MIL-R-85664(AS)  
AMENDMENT 1  
7 JULY 1987

MILITARY SPECIFICATION

RECEIVER-TRANSMITTER, RADIO  
RT-1250A/ARC

This amendment forms a part of Military Specification MIL-R-85664(AS), dated 3 June 1985, and is approved for use within the Naval Air Systems Command, Department of the Navy and is available for use by all Departments and Agencies of the Department of Defense.

FIGURE 4. Electronic Equipment Mounting Base MT-4934/ARC and Radio Receiver-Transmitter RT-1250A/ARC, Outline and Mounting Dimensions

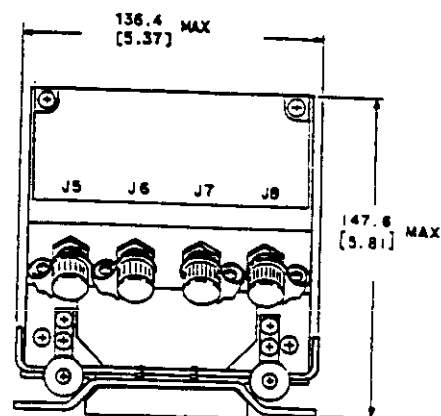
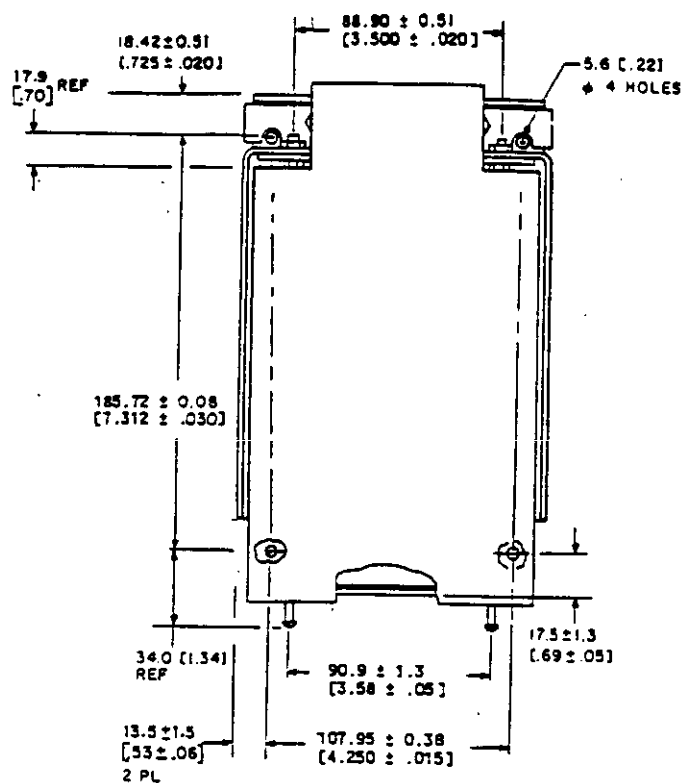
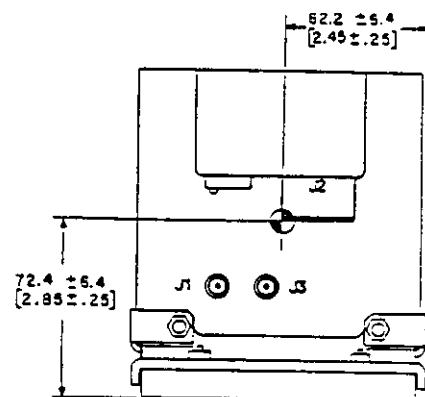
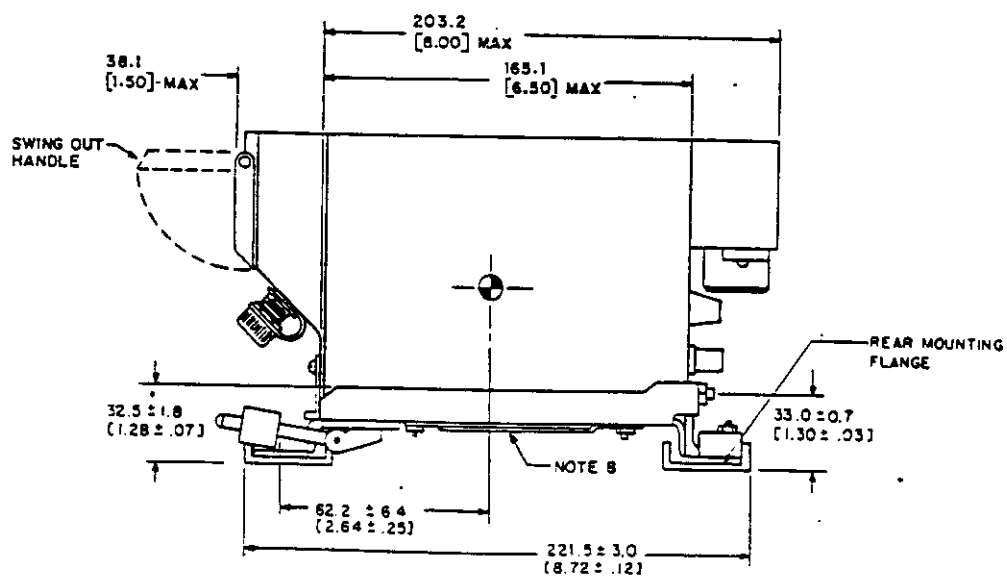
Delete Figure 4 and substitute new Figure 4.
